# LiDAR Quality Assessment Report

UT\_GSLNorth\_2011

This data set was collected from airborne surveys completed between September 27, 2011 and October 10, 2011 and covers approximately 619 square miles contained in the following county(s): Box Elder County, Utah; Weber County, Utah.

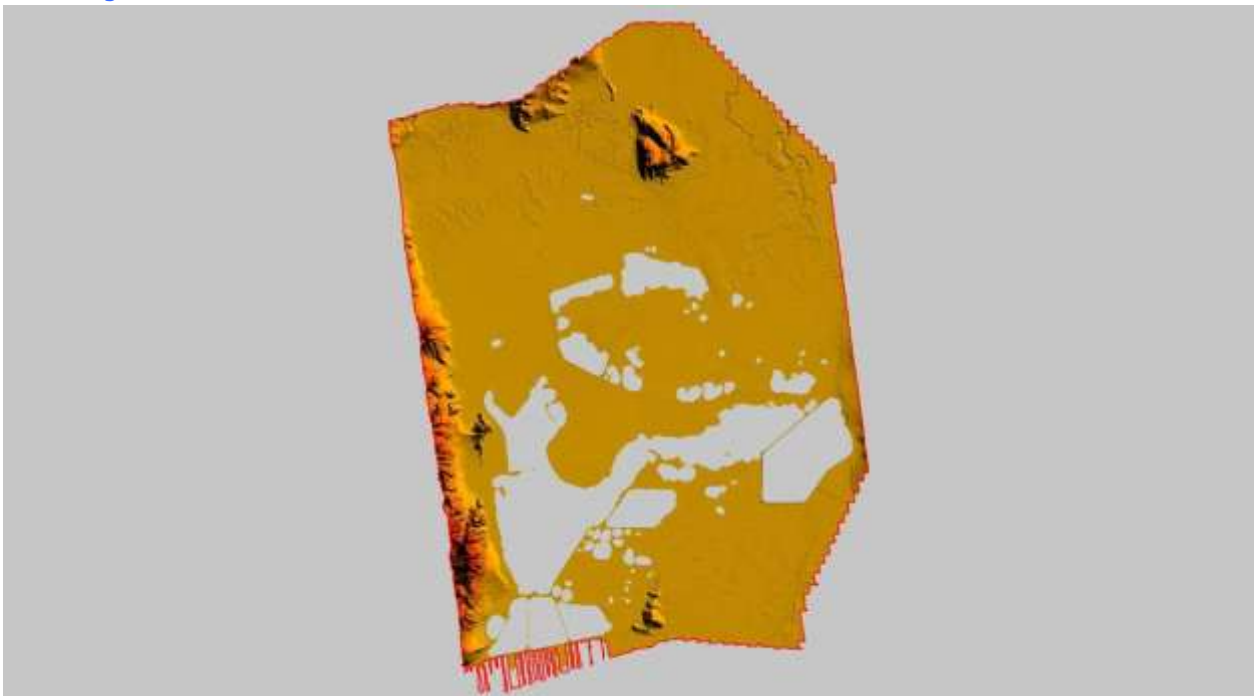
DEM Tiles do not Perfectly Conform to the Tiling Scheme in Terms of Quantity, i.e., 459 DEM Tiles out of a Tile Scheme of 463 Tiles. As noted above, lake water has been removed and set to no data, rather than flattened, the Missing DEM tiles fall in these no data water areas. Missing Tiles are: GSL\_North\_000379, GSL\_North\_000149, GSL\_North\_000282, GSL\_North\_000338.

There are also several instances of Overlapping DEM Tiles or tiles which have the same data. These tiles include: (409,410), (455,461), (456,462), (457,463), (445,460), (435,449,450). They do not present a problem in the USGS created Mosaic.

Mosaic of original DEM tiles above, many water areas gridded as "no data".

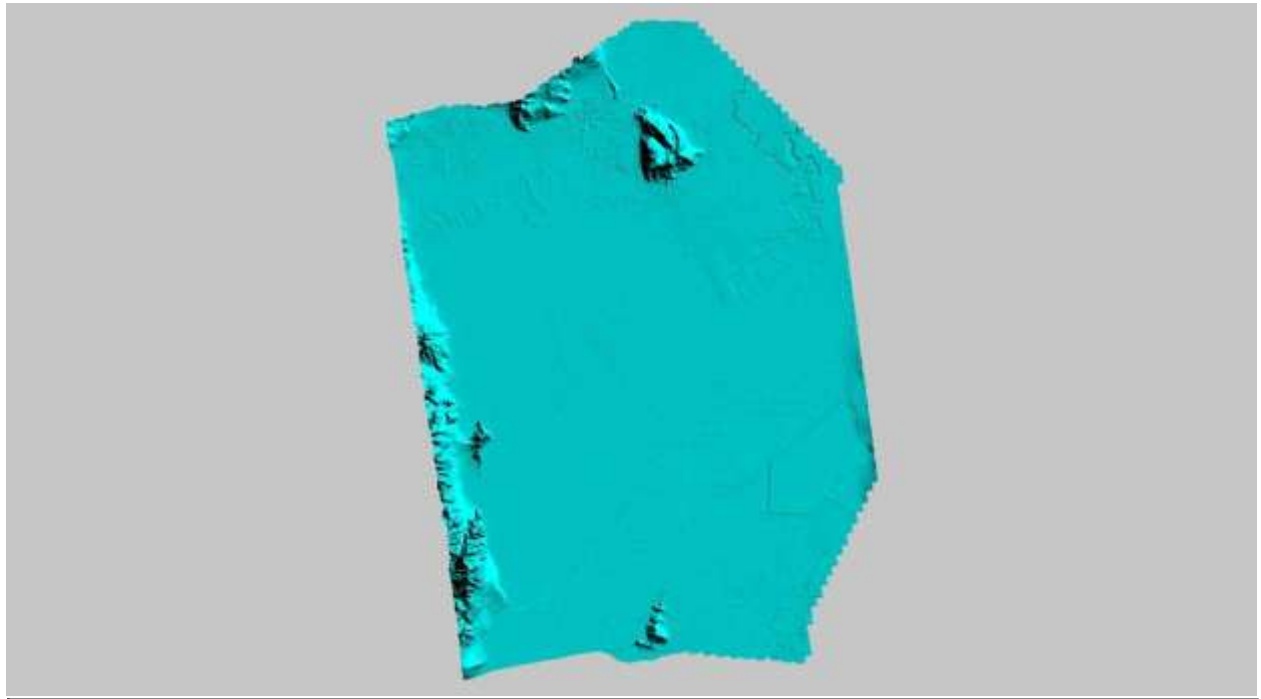
Note that Lake Areas are not gridded at a constant value in DEMs, but is removed or no data.

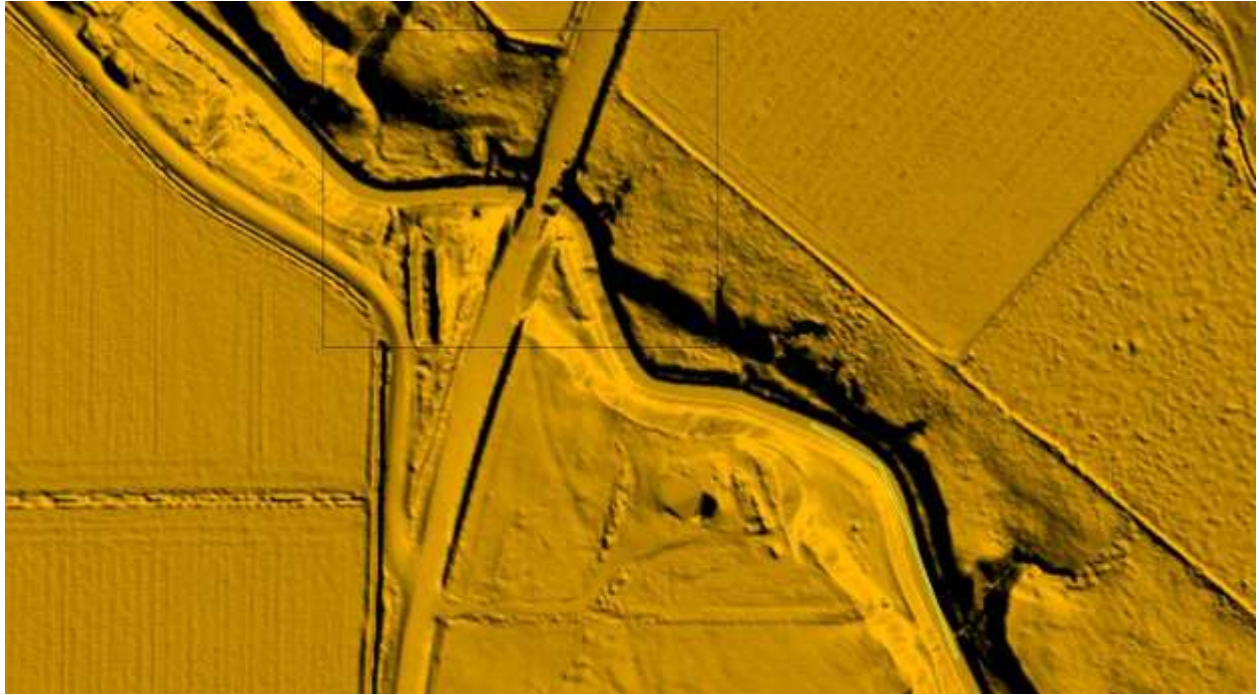
In order to make the DEM usable in the 1/9th NED the Water needed to have a value, A final mosaic was created by the USGS that coded each interior lake with a constant (flat) value of the lowest bordering pixel. The project boundary for the project was also determined to be the maximum swath extents and was buffered in by 100 Meters and cut out on the southern portion to ensure there were no gaps in the data due to the flight lines. The final product sent to the NED should be free of data voids and have adequate point density for gridded areas included in the final mosaicked DEM. This also has an accompanying DEM Project Footprint and is 607.40 SqMi.

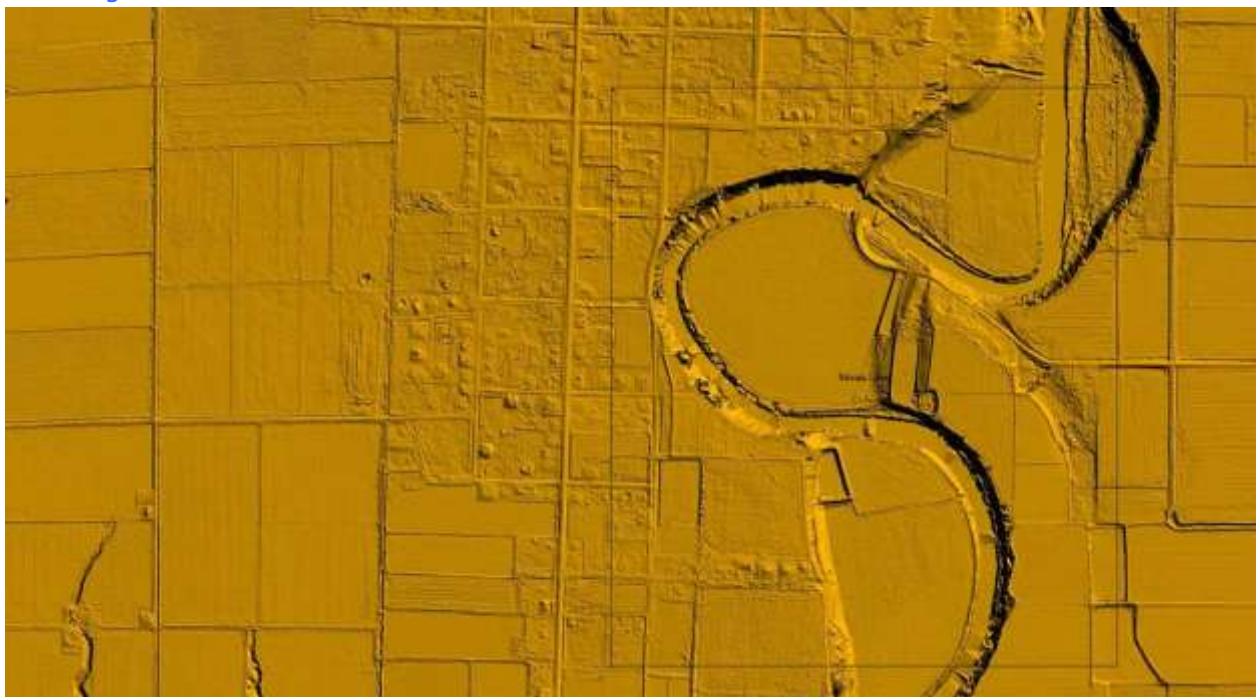
Several instances of bridge or overpass removal. Errors tagged as "Bridge" are highly suspect; whereas, errors tagged as "overpass or culvert" could not be determined if they needed to be removed or where culverts in the ground.

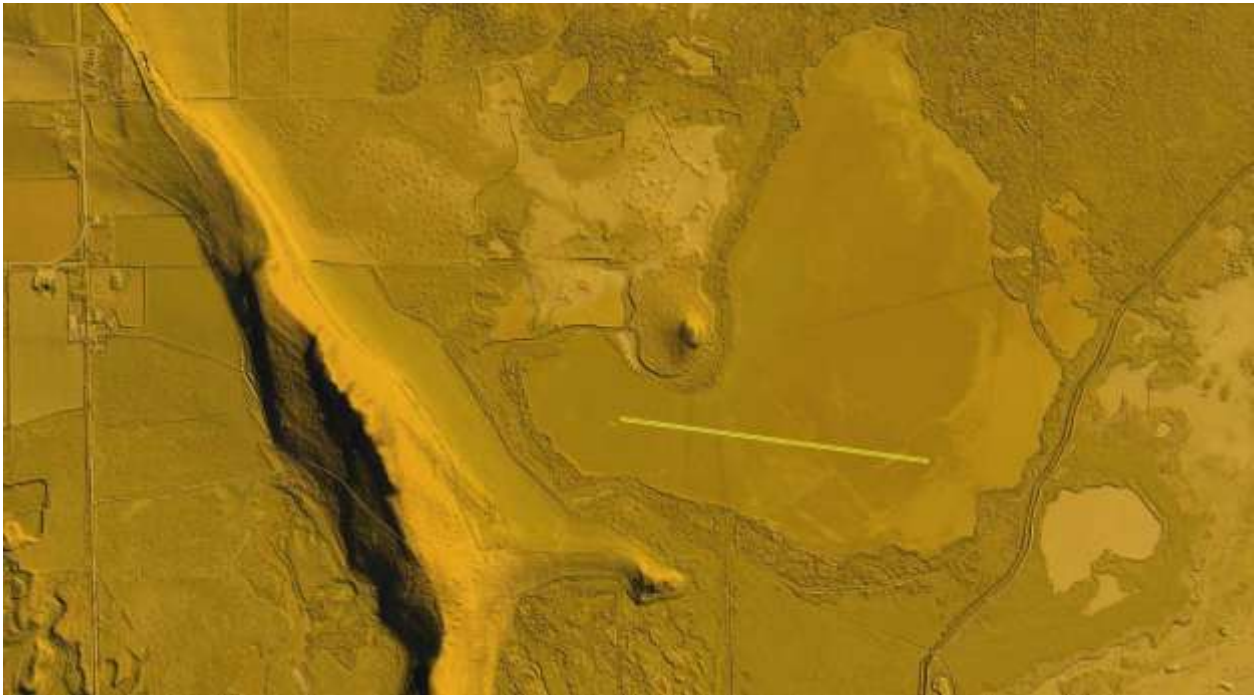
A few instances of questionable structure removal. Errors denoted with the tag "building removal".
